MS context release indication

Introduction

Figure 1 an example of MS context release in old access RS

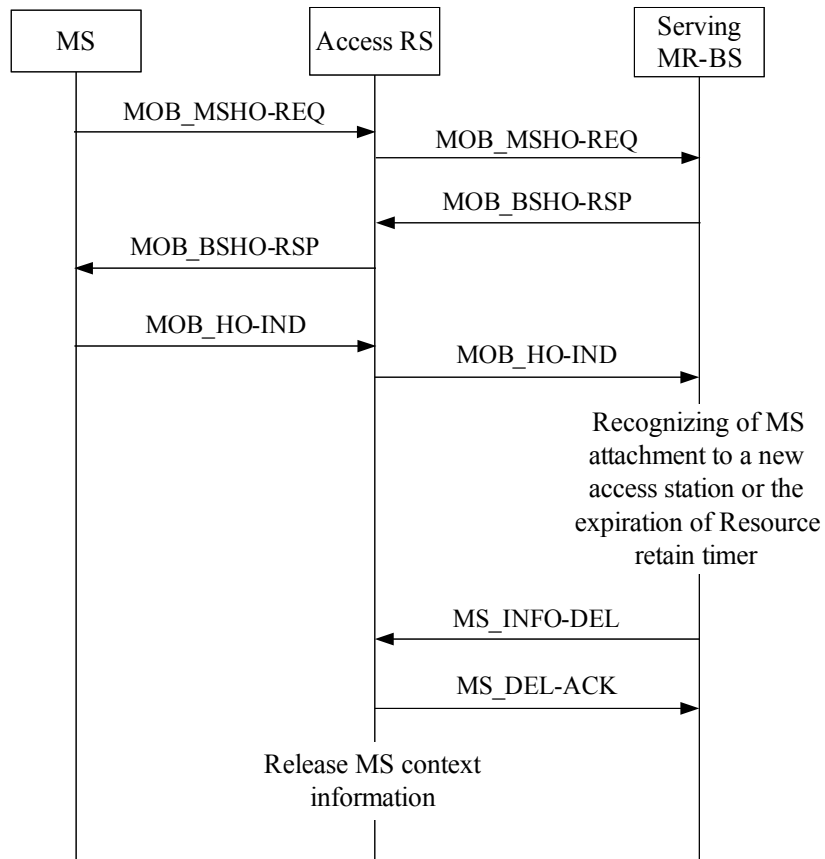
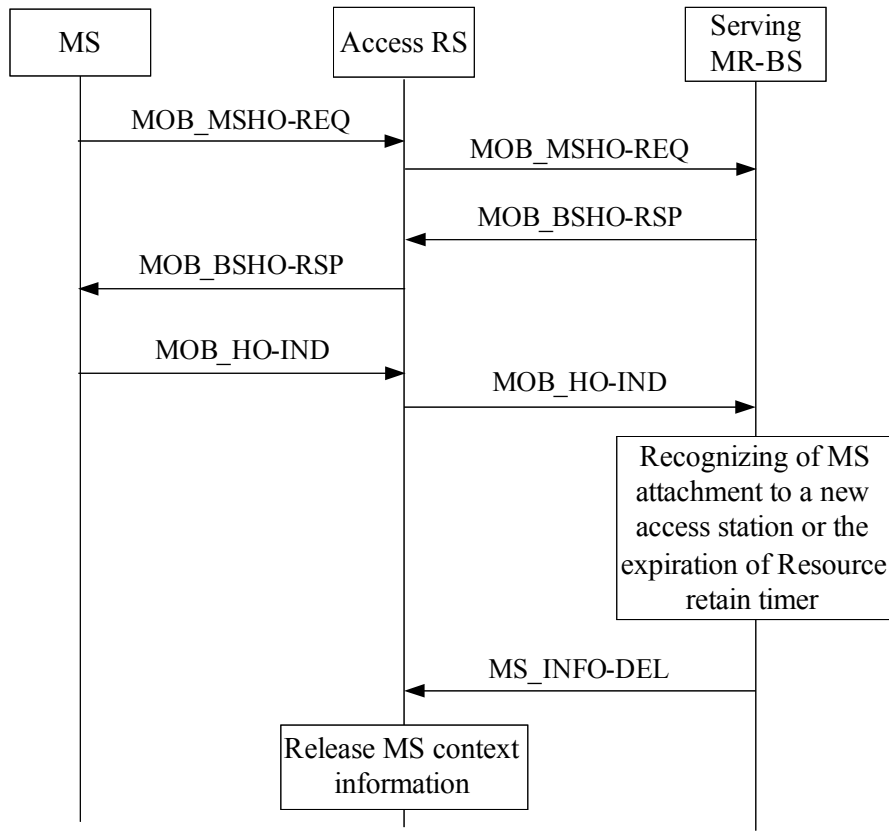
This contribution proposes handover signals to inform an old access RS that MS has successfully attached itself to a new access station and make the RS release MS context information if it maintains the information.

Similarly in 802.16j, RS as an old access station may maintain MS context information such as MS CIDs while an MS moves to another access station. After the MS attaches to the new access station or the expiration of Resource retain timer negotiated between serving MR-BS and MS, the old access RS does not need to retain the MS context information. So the serving MR-BS informs the old access RS of the release of MS context information if the RS maintains it. Upon receiving a signal of MS context release, the old access RS shall send its acknowledgment to the MR-BS and release the saved MAC context of the MS.

Figure xx: Handover procedure involving RS with centralized HO control from MR-BS

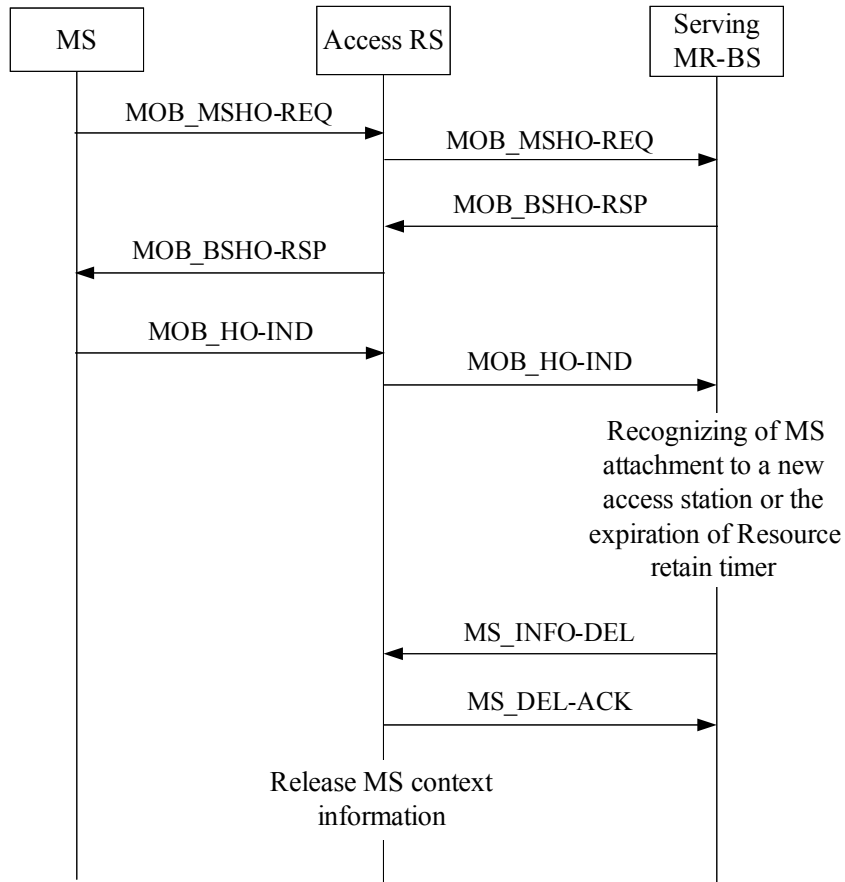
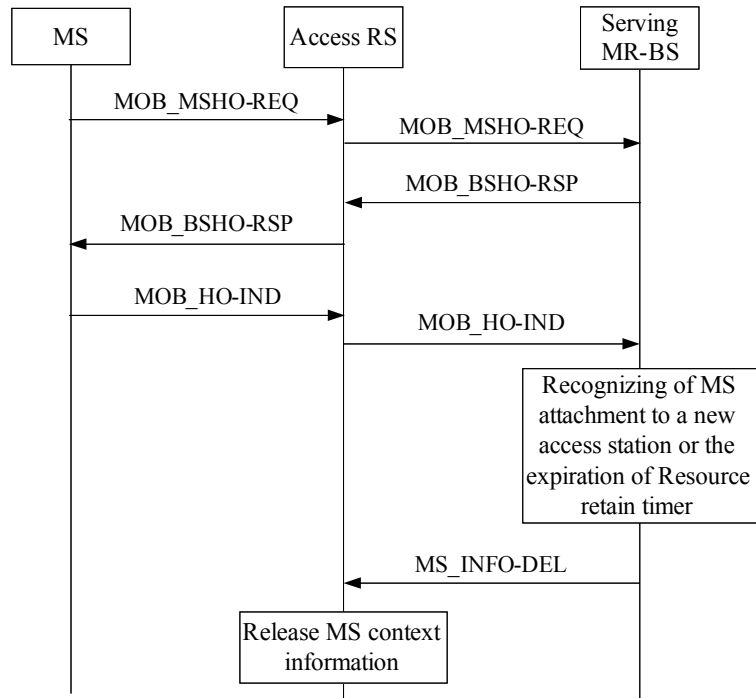
[Insert the followings at the end of section 6.3.22.5.1 in page 30]

If a serving MR-BS recognizes that MS attaches to a new access station or Resource retain timer expires, and the MS's old access station is an RS which is controlled by the MR-BS, the MR-BS may send the MS_INFO-DEL message to make the RS discard MS context information. Upon receiving the MS_INFO-DEL message, the RS shall transmit MS_DEL-ACK as a reply and remove the MS context information.
